## **HERRINGTON'S SUBDIVISION**

APPLICATION NUMBER 2 DATE January 7, 2010

REQUEST Subdivision

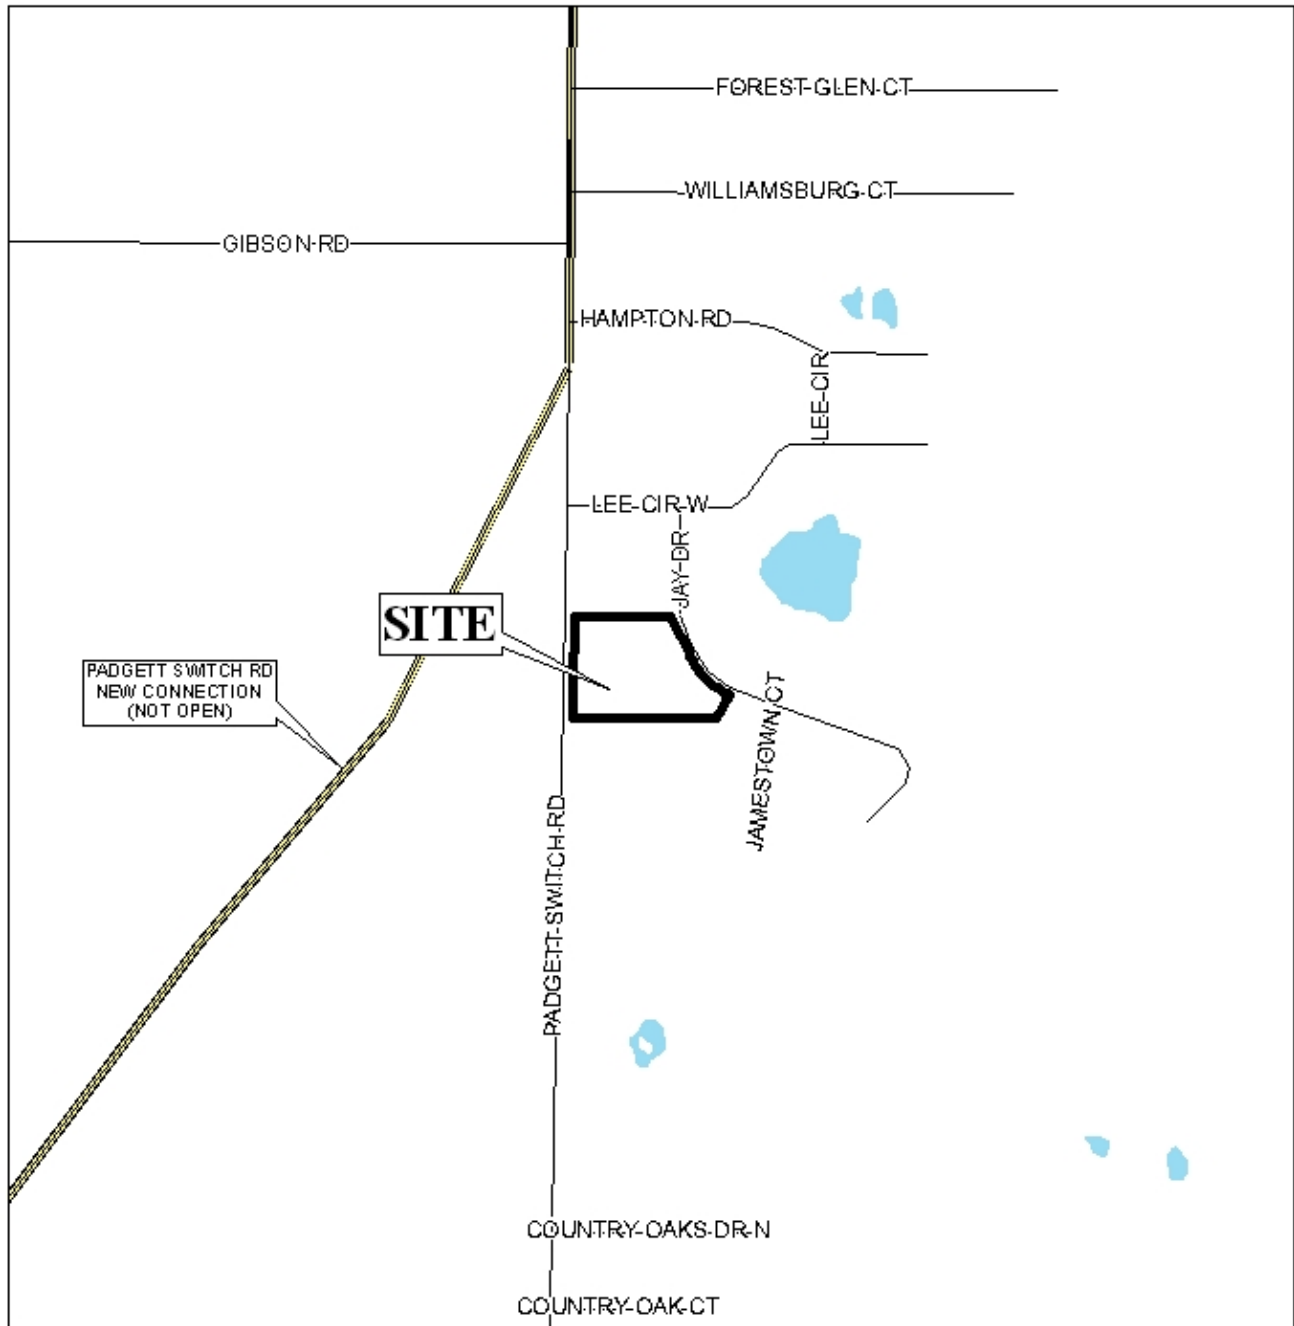
It should further be noted that the legal description of the subdivision does not include the proposed Lot 5, and, as such, the legal description on the plat should be revised to include that portion of the site.

The sizes of the proposed lots are not shown on the preliminary plat; however, all appear to meet the minimum size requirements as regulated by Section V.D.2 of the Subdivision Regulations. As the lot sizes are not indicated, the plat should be revised to indicate the lot size, in square feet, or a table provided on the plat showing the same information.

The proposed Lot 4 is depicted with access to both Padgett Switch Road and Jamestown Drive. Double frontage lots generally do not comply with Section V.D.8 of the Subdivision Regulations. However, in order to maintain the character of the existing subdivision, a waiver of this section may be appropriate. If a waiver is approved, then access to Jamestown Drive should be denied due to the site already accessing Padgett Switch Road.

The existing curb cuts to site are depicted on the preliminary plat. The proposed Lot 4 is depicted with two existing curb cuts to Padgett Switch Road, and the proposed Lot 5 is depicted with one curb cut to Padgett Switch Road. No other existing curb cuts (if any) to any other road are depicted. The proposed Lot 1, with 214 feet of frontage along Padgett Switch Road should be limited to two curb cuts to the same. The proposed Lot 3 should be limited to one curb cut to Jamestown Drive, and the proposed Lot 2 should also be limited to one curb cut to Jamestown Drive. The size, design, and location of all curb cuts should be approved by Mobile County Engineering and conform to AASHTO standards.

The 25-foot minimum building line is depicted on all lots and right-of-way except on the proposed Lot 5. The final plat, if approved, should be revised to depict the 25-foot building setback line along Padgett Switch Road on the proposed Lot 5.

*The applicant has submitted documentation from the property owner of the proposed Lot 5 (West 290 feet of Lot 1, Resubdivision of Lot 22 Jamestown Estates First Addition MB 67 MP 54) indicating their willingness to participate in the subdivision request. Also, the applicant has submitted a revised plat and revised legal description. Additionally, that plat was revised to depict the 25-foot building setback line along all public rights-of-way.*

Based on the preceding, and with a waiver of Section V.D.8 of the Subdivision Regulations, the plat is recommended for tentative approval subject to the following conditions:

- 1) Placement of a note on the final plat stating that Lot 4 is denied access to Jamestown Drive;
- 2) Placement of a note on the final plat stating that Lots 4 and 5 are limited to the existing curb cuts to Padgett Switch Road;

- 3) Placement of a note on the final plat stating that Lot 1 is limited to one curb cut to Padgett Switch Road;
- 4) Placement of a note on the final plat stating that Lots 2 and 3 are limited to one curb cut each to Jamestown Drive;
